RE: Lycee Francais Renovation
1601 Leonidas Street
New Orleans, LA 70118
Proposal # 048

ARCHITECT'S SUPPLEMENTAL INSTRUCTION NO: 020**DATE OF ISSUANCE: 7/20/21**

Project: LYCEE FRANCAIS DE LA NOUVELLE-ORLEANS (LFNO)
1619 LEONIDAS STREET
NEW ORLEANS, LA 70118

Provide fire and smoke dampers as shown on the attached sheets.

1 FIRST FLOOR - DUCTWORK - PLAN
M2.1 1/8" = 1'-0"

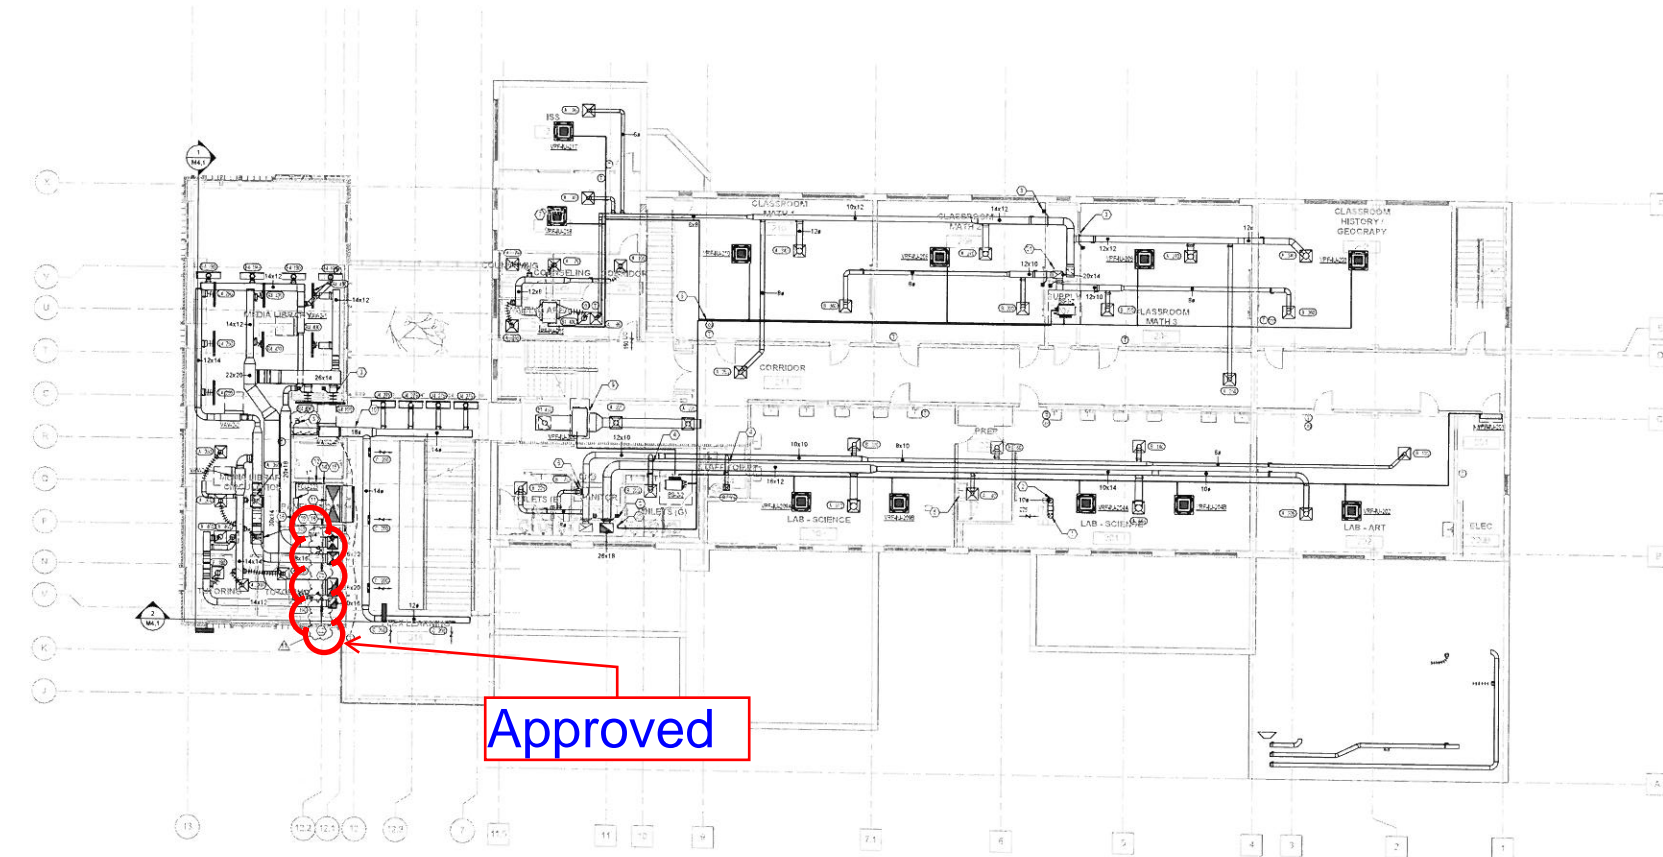
1. ROUTE 2" DUCTWORK OUTSIDE AIR VENT AND REFRIGERANT LINE IN ENTRY TEST TO STRUCTURE. PROVIDE FIRE DAMPERS AS INDICATED. ENSURE LOCATIONS ARE ACCESSIBLE FOR MAINTENANCE. FIRE CAULK PIPING PER DETAILS.

8. PROVIDE FIRE RATING DAMPERS AT INDICATED LOCATIONS. COORDINATE POWER AND FIRE PLUMBING WITH SERIAL IN.
9. PROVIDE EXHAUST DUCT AS INDICATED FROM GAS WATER HEATERS TO SIDEWALL EXHAUST CAP. COORDINATE WITH ARCHITECT AND WATER HEATER MANUFACTURER REQUIREMENTS. TYPICAL 2.

1 SECOND FLOOR - DUCTWORK - PLAN
M2.2 1/8" = 1'-0"

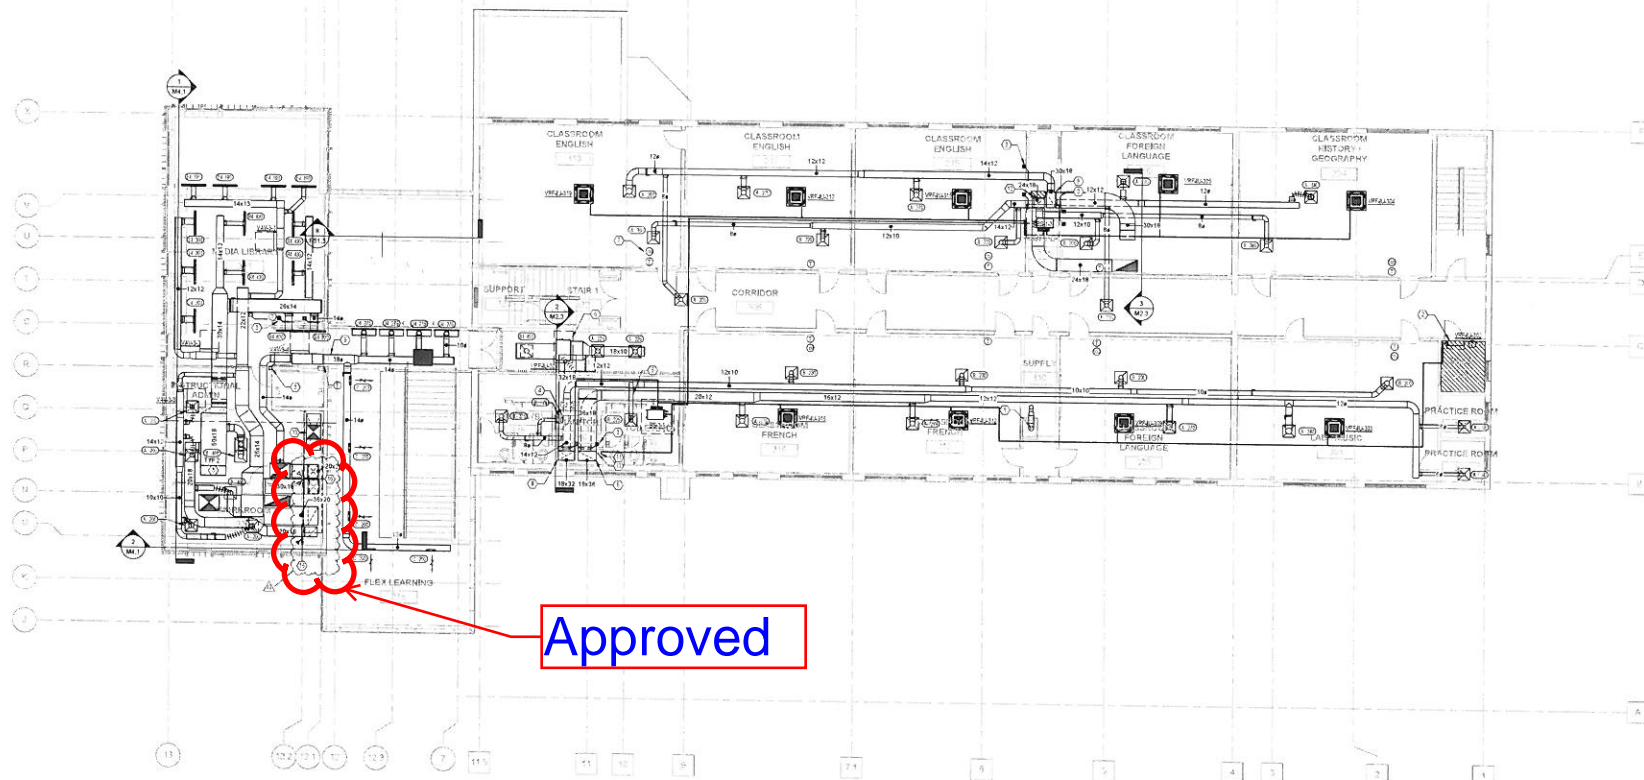
2. ROUTE 10" DIAMETER STAINLESS STEEL DUCT TO ROOF IN CHASE.
3. PROVIDE FIRE SMOKE DAMPERS AT INDICATED LOCATIONS. COORDINATE POWER AND FIRE ALARM WITH DIVISION 26.

21. INSTALL FIRE DAMPERS AT FIRE RATED WALL PENETRATIONS.

1 THIRD FLOOR - DUCTWORK - PLAN
M2.3 1/8" = 1'-0"

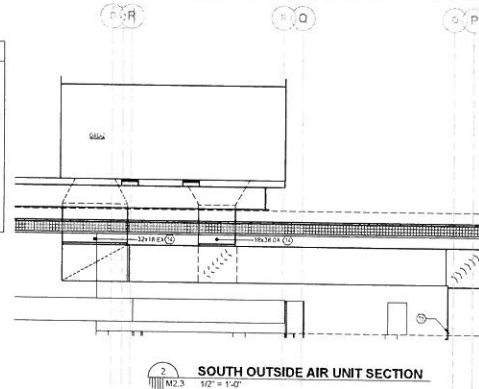
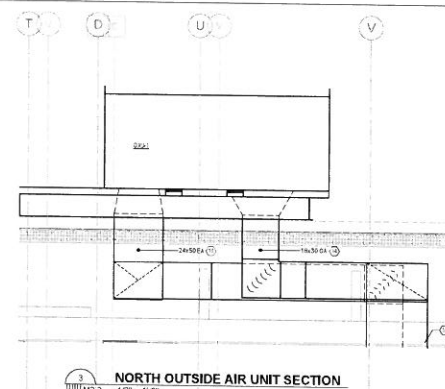
3. PROVIDE FIRE SMOKE DAMPERS AT INDICATED LOCATIONS. COORDINATE POWER AND FIRE ALARM WITH DIVISION 25.
4. ROUTE CONDENSATE FOR ADJACENT VAV SYSTEMS TO ROOF SINK THIS LOCATION. SLOPE PIPING TOWARDS DRAIN.

1 FIRST FLOOR - DUCTWORK - PLAN
M2.1 1/8" = 1'-0"

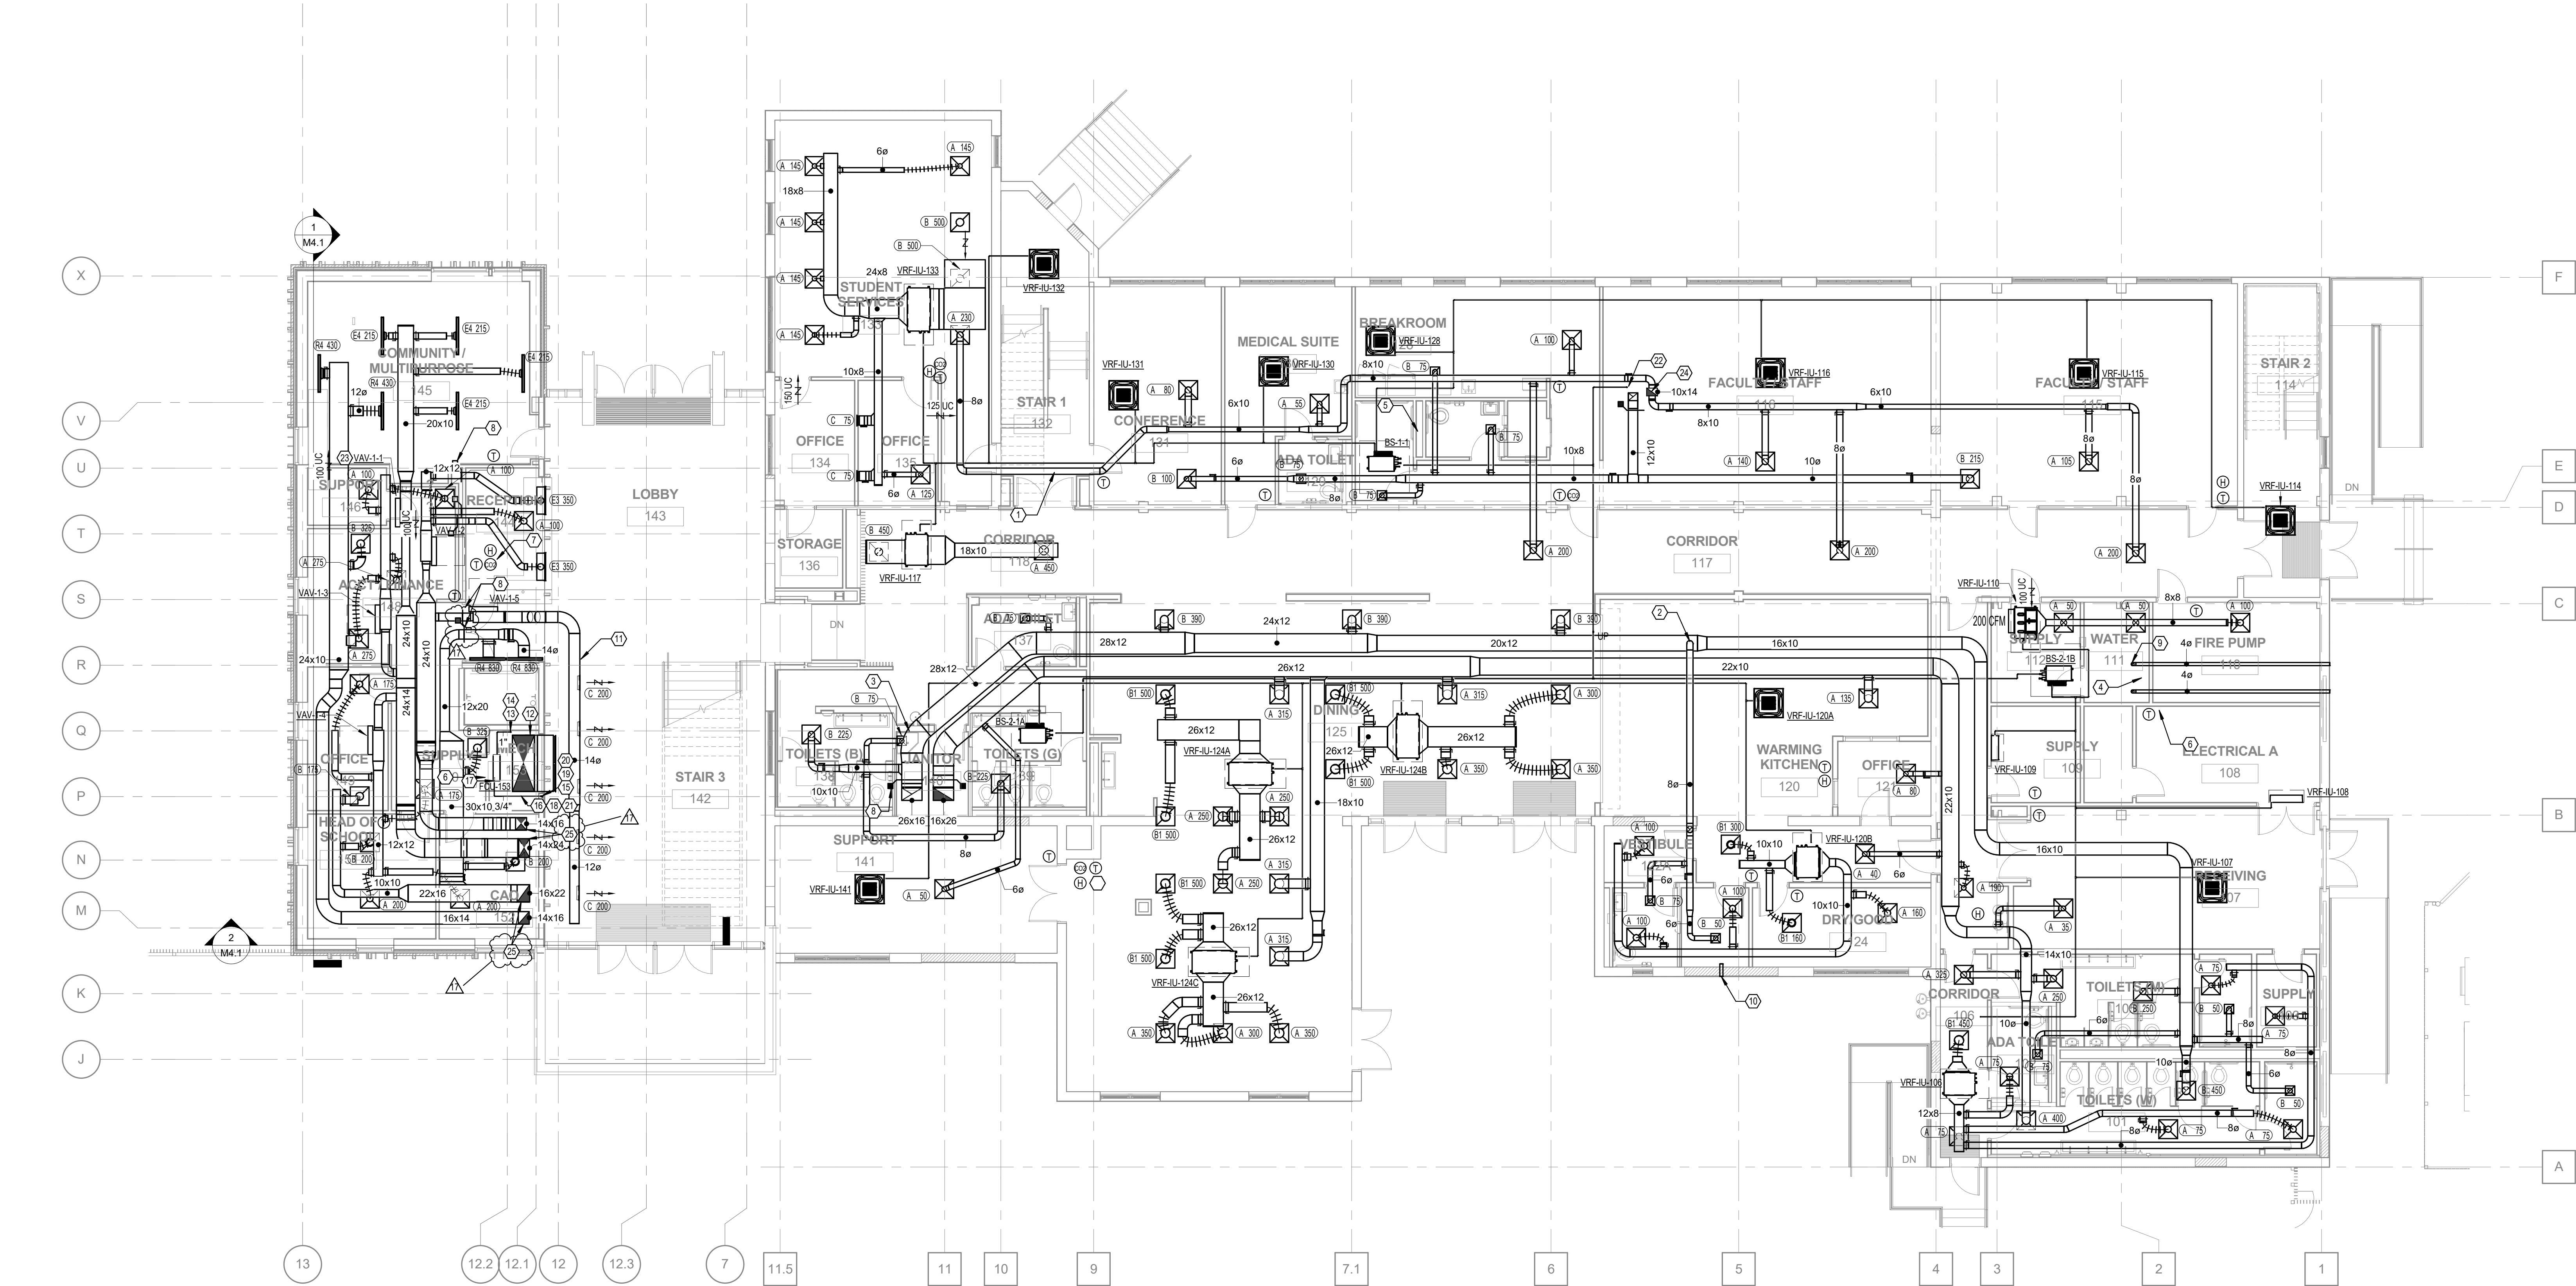
- # KEYED NOTES
- ROUTE 6" DIAMETER OUTSIDE AIR DUCT AND REFRIGERANT LINES IN SOFFIT TIGHT TO STRUCTURE. PROVIDE FIRE DAMPERS AS INDICATED. ENSURE LOCATIONS ARE ACCESSIBLE FOR MAINTENANCE. FIRE CAULK PIPING PER DETAILS.

- PROVIDE FIRE SMOKE DAMPERS AT INDICATED LOCATIONS. COORDINATE POWER AND FIRE ALARM WITH DIVISION 26.
 - PROVIDE EXHAUST DUCT AS INDICATED FROM GAS WATER HEATERS TO SIDEWALL EXHAUST CAP. COORDINATE WITH ARCHITECT AND WATER HEATER MANUFACTURER REQUIREMENTS. TYPICAL 2.

- REFRIGERANT PIPE ROUTED UP TO CU-3.
 - PROVIDE ELECTRICAL DISCONNECT ON BOTTOM OF VAV BOX.
 - INSTALL FIRE SMOKE DAMPER AT FLOOR PENETRATION AND COORDINATE POWER AND FIRE ALARM WITH DIVISION 26.

- INSTALL FIRE DAMPER AT FLOOR PENETRATION.

1 SECOND FLOOR - DUCTWORK - PLAN
M2.2 1/8" = 1'-0"

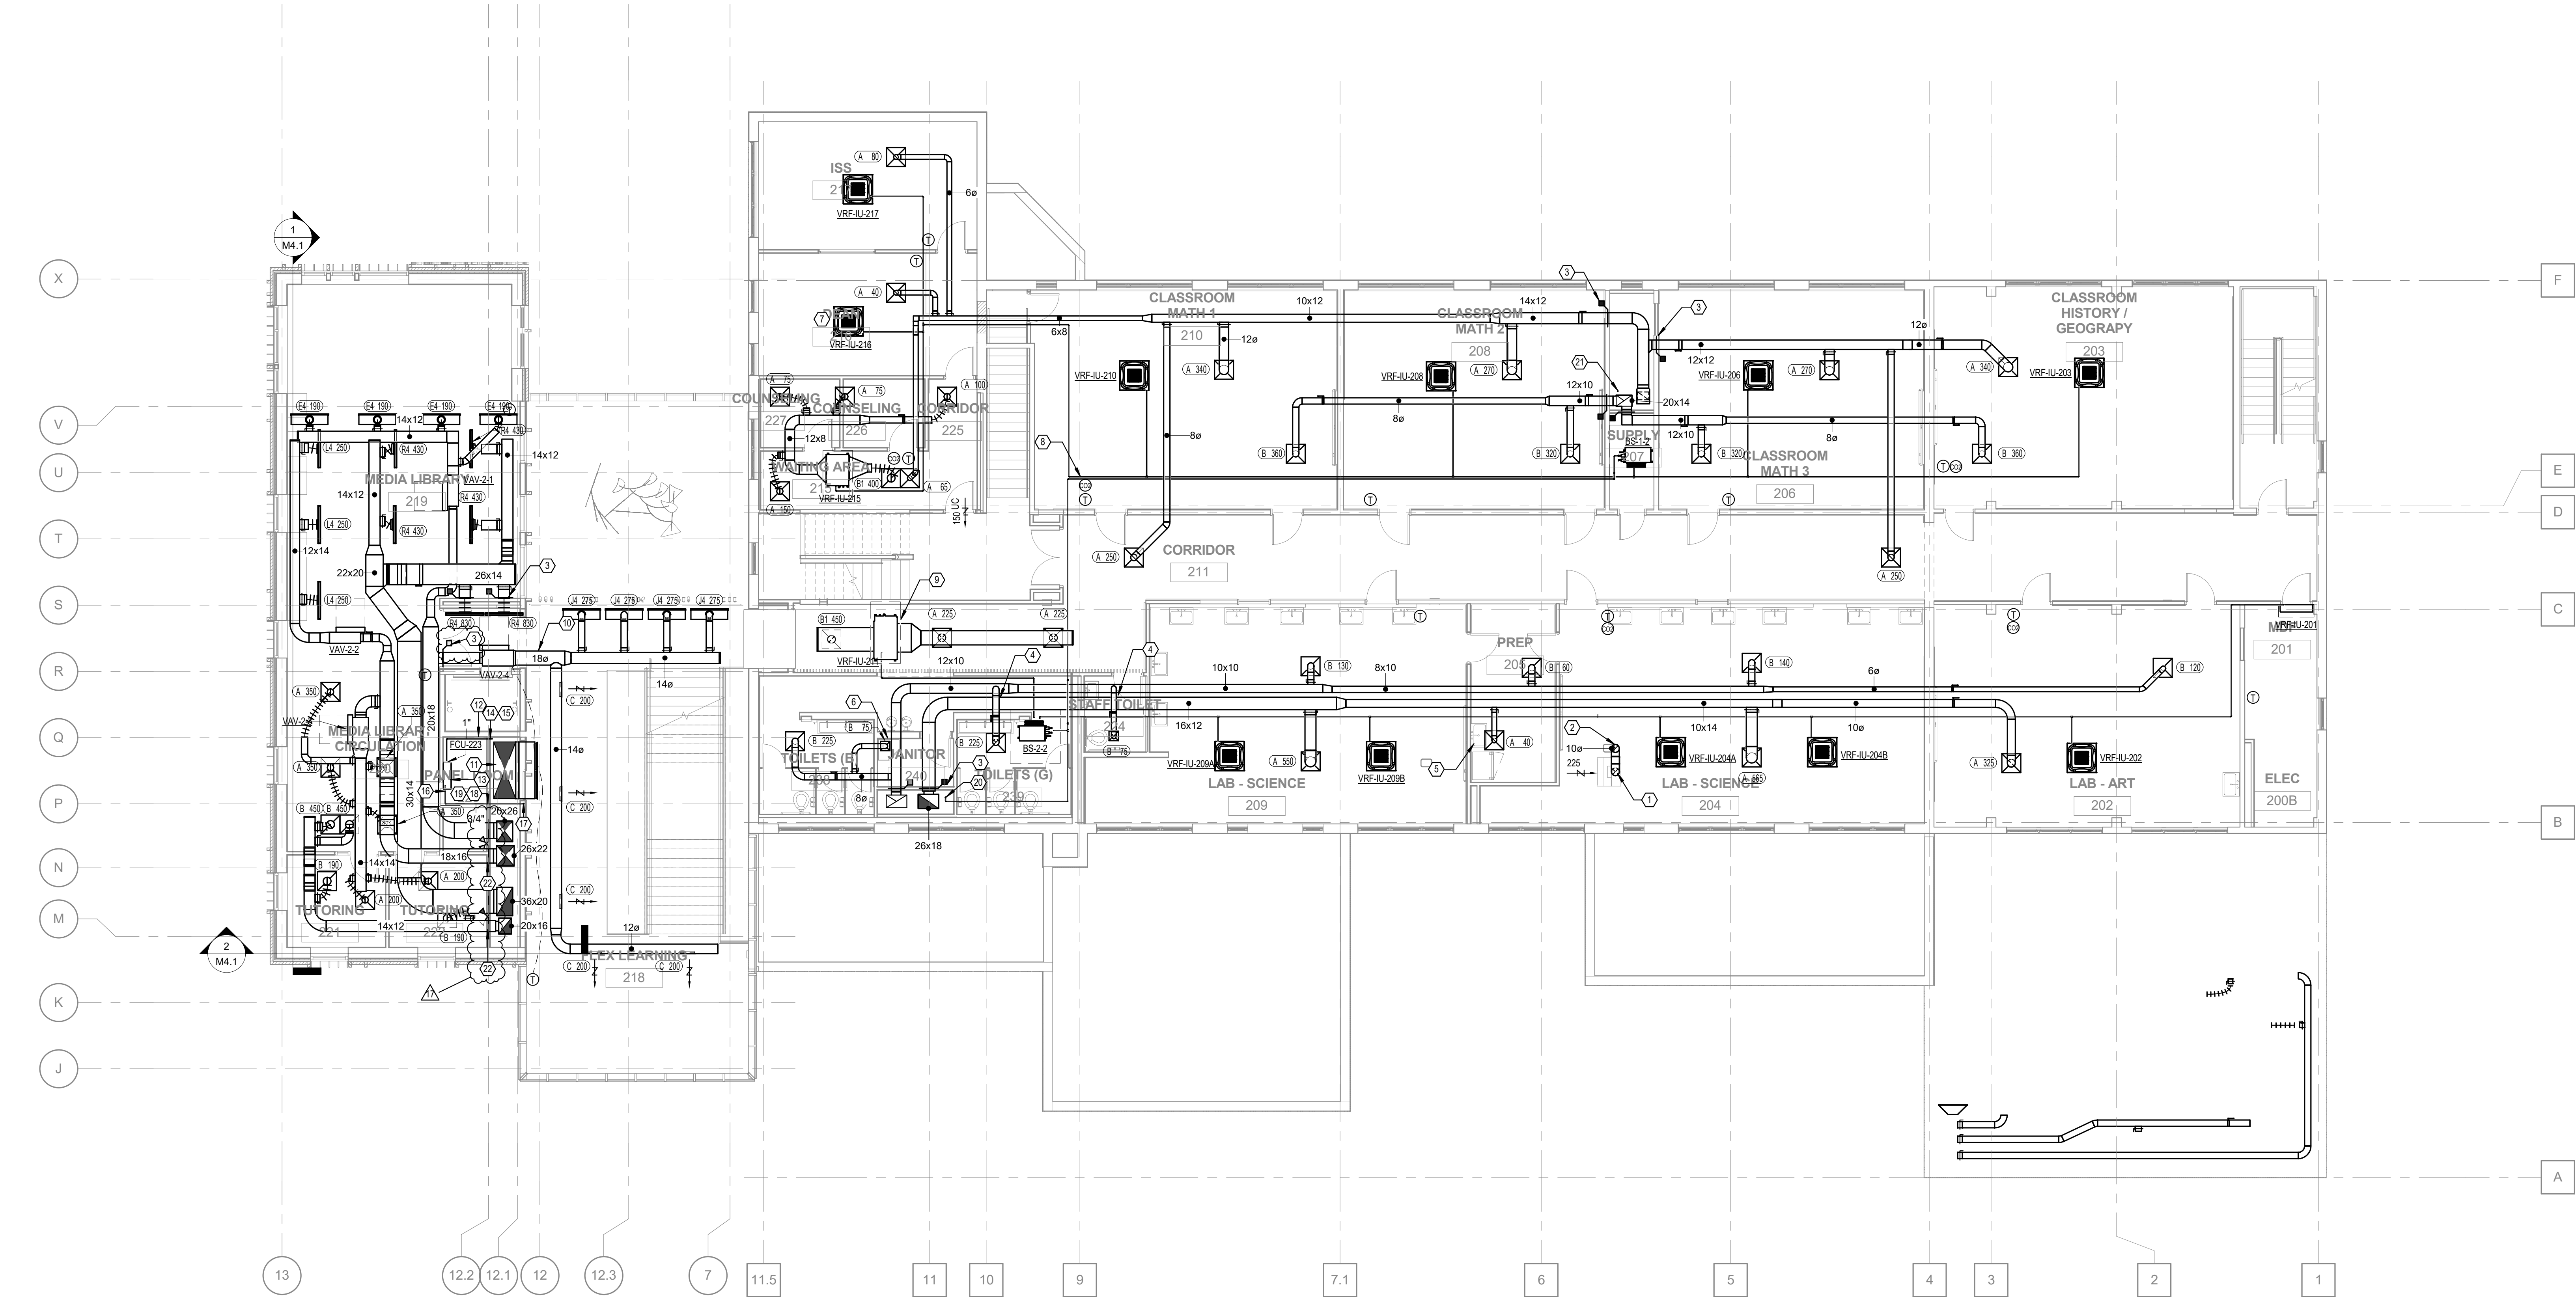
- ROUTE 10" DIAMETER STAINLESS STEEL DUCT TO ROOF IN CHASE.
 - PROVIDE FIRE SMOKE DAMPERS AT INDICATED LOCATIONS. COORDINATE POWER AND FIRE ALARM WITH DIVISION 26.

- ROUTE REFRIGERANT PIPING UP TO CU-1.
 - INSTALL FIRE DAMPER AT FIRE RATED WALL PENETRATION.
